DEREHAM TOWN COUNCIL

At a meeting for **Plans** at the Memorial Hall on **Tuesday 11th October 2022** at **7.00pm**.

3. 3PL/2022/1050/D

Land off Swanton Road

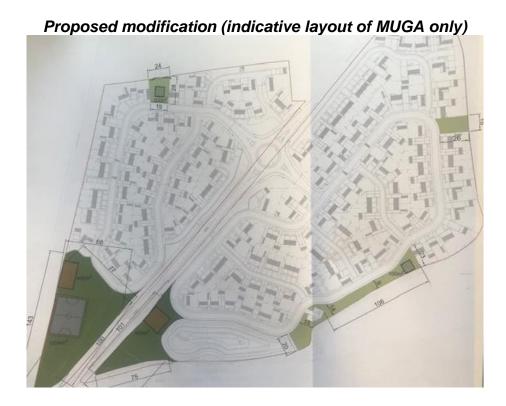
While Dereham Town Council are generally happy with this development they are extremely unhappy and concerned with the proposed treatment of the level crossing. The proposal only provides for a footway on the northside of the level crossing, the Council finds this wholly unacceptable and unsafe. Somebody living on the south side of this development and wanting to walk their children to King's Park will need to cross the road twice. This simply will not happen when people are in a hurry, they will take the quickest route and walk in the carriageway. As a minimum there needs to be a footway on both sides of the road, over the level crossing. What is presented in this application is very different from what was shown to the Planning Committee at the outline stage. When the decision was made to approve this application at outline stage, a plan was presented which showed a pedestrian path on the southern side of the level crossing and a shared use walking and cycling route on the north side, creating a safe cycle route to Cemetery Road. This arrangement would have been compliant with the Breckland Policy TR01 which states that sustainable transport will be achieved through (amongst other things):

The Town Council are mindful that this application could be the first of further applications coming forward on the eastern side of the level crossing. If what is proposed is deemed acceptable then it may not be just for 216 properties, it could be

for a much larger number. It is important to get the treatment of the level crossing right for this first application.
